# Access Compliance Report

## Public Rights-of-Way

### (Curb Ramps)

Intersection ID: 42667	Main Street: WALLACE_GLEN_DR	Cross Street: WALLACE_VIEW_CT	Location: SW
ADA ID: 75A52F6A6151	Ramp Type: PerpDiag	Initial Pass/Fail: Fail	Overall Compliance: No
		Severity Score: 10

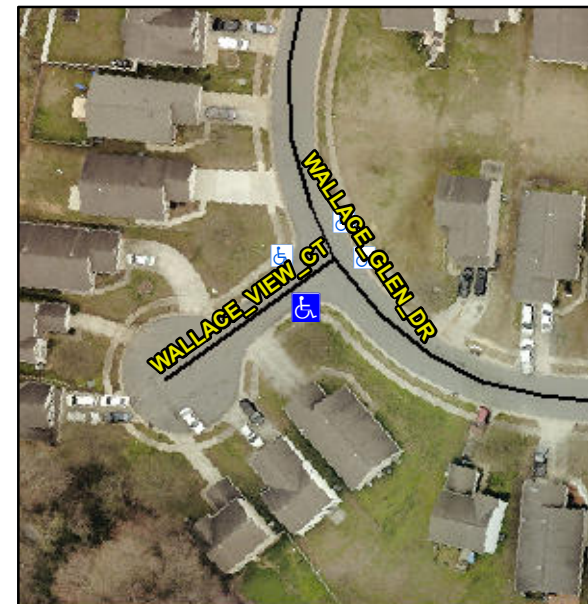
**R304.5.1, R304.5.3**

Compliance	Description	Data	Compliance	Description	Data
N/A	Ramp Length (in)	48.0	Yes	Ramp Slope (%)	8.1
No	Ramp Width (in)	44.0	No	Ramp XSlope (%)	3.4
N/A	Flare Type LT	N/A	N/A	Flare Type RT	N/A
N/A	Flare Slope LT (%)	N/A	N/A	Flare Slope RT (%)	N/A
N/A	Flare Traversable LT?	N/A	N/A	Flare Traversable RT?	N/A
N/A	Landing Length (in)	N/A	N/A	DWS Provided?	N/A
N/A	Landing Width (in)	N/A	N/A	DWS Contrast?	N/A
N/A	Landing Slope (%)	N/A	N/A	DWS Length (in)	N/A
N/A	Landing X Slope (%)	N/A	N/A	DWS Full Width?	N/A
N/A	Landing Curb? (Y/N)	N/A	N/A	DWS Offset (in)	N/A
N/A	Shared Landing?	N/A			
N/A	Gutter Ponding?	N/A	N/A	Gutter Slope (%)	N/A
N/A	Gutter Lip Ht (in)	N/A	N/A	Gutter X Slope (%)	N/A
N/A	Painted X Walk1?	No	N/A	Painted X Walk2?	No
	X Walk 1 Direction	To E		X Walk 2 Direction	To N
N/A	X Walk 1 Width (in)	N/A	N/A	X Walk 2 Width (in)	N/A
	X Walk 1 Slope (%)	2.2		X Walk 2 Slope (%)	1.6
	X Walk 1 X Slope (%)	1.9		X Walk 2 X Slope (%)	2.3

**Remove & Replace Curb Ramp With Two New Directional Ramps or Equivalent.**
